Product hierarchy no. *	Part no.	SBU	Type / Description	Customer part no.
SBU PG PGU Type	i artito.	000		
02 005 016 0000001300	See list below	Power Entry Module	6145	
*SBU (2-digit) / PG (3-digit) / PGU (3-dig	git) / Type (10-digit)		ц	I
List of part numbers affected	ed			
6145.0012.001 6	145.0847.001	6145.2105.001	6145.2834.001	6145.3213.001
6145.0022.001 6	145.0885.001	6145.2173.001	6145.2836.001	6145.3214.001
6145.0024.001 6	145.0977.001	6145.2217.001	6145.2837.001	6145.3431.001
6145.0031.001 6	145.0991.001	6145.2269.001	6145.2838.001	6145.3436.001
6145.0470.001 6	145.1089.001	6145.2307.001	6145.2852.001	
6145.0586.001 6	145.1356.001	6145.2405.001	6145.2857.001	
6145.0617.001 6	145.1477.001	6145.2507.001	6145.2882.001	
6145.0764.001 6	145.1573.001	6145.2754.001	6145.2950.001	
6145.0816.001 6	145.2078.001	6145.2755.001	6145.3000.001

6145			0118.2265			
creation date	created by	release date	released by	notification no.	revision	page
2015-01-19	huberth	2015-08-05	huberth		-	1 of 2

# PRODUCT CHANGE NOTIFICATION

#### 1 Products affected

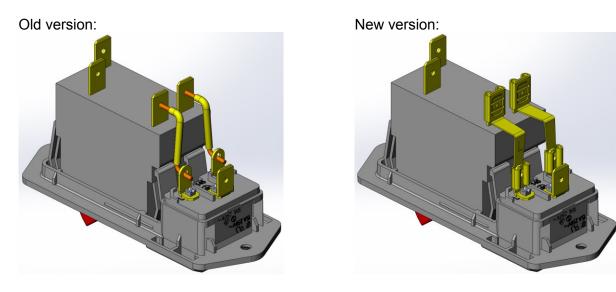
Soldered wire connection between connector and circuit breaker replaced by faston connection.

Form:	Yes	New connection on back side, no change of outer dimensions.
Fit:	No	There are no dimensional changes.
Function:	No	This is a non-functional change.
Production Site:	No	There is no change of the production site.
Product Label:	No	There is no change on the label.
